# **Application for mining lease, Shark Bay**

Environmental Protection Authority Bulletin 468 November 1990

# Application for mining lease 09/41 for fine dune sand, south-east of Denham, Shark Bay

Figure 2: Area proposed for sand excavation

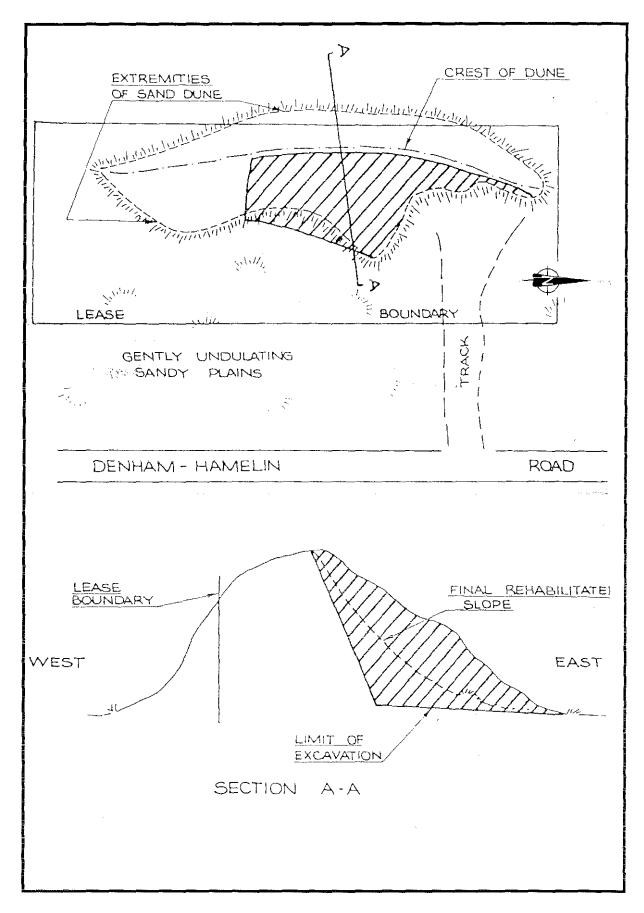
The mining plan to protect the seaward and upwind portions of the dune is desirable as the deposit is in a coastal area where it is subject to the full effect of southerly summer winds without the ameliorating effect of distance from the coast or screening by taller denser vegetation.

The mine plan is environmentally acceptable provided rehabilitation of the dune is carried out quickly and effectively. Rehabilitation should occur in consultation with the Department of Conservation and Land Management and should be progressive in order to avoid prolonged exposure of the disturbed dune surface to erosive factors such as wind and rain.

Rather than remove the top metre as a topsoil stockpile, it is recommended that the top 20 centimetres of sand should be stripped first and retained separately to the remaining 80 centimetres as this top layer contains most of the stored seed. As each section of the dune is worked out it should be covered with the stockpiled sand with the material from the top 20 centimetres on top; the dune should be progressively reshaped and rehabilitated. This will ensure minimal physical impact to the dune and minimise any visual impact. Local species should be used for rehabilitation.

The Environmental Protection Authority recommends that the proponent should develop a rehabilitation plan in consultation with the Department of Conservation and Land Management, and progressively rehabilitate the disturbed areas to the satisfaction of the Environmental Protection Authority on advice from the Department of Conservation and Land Management.
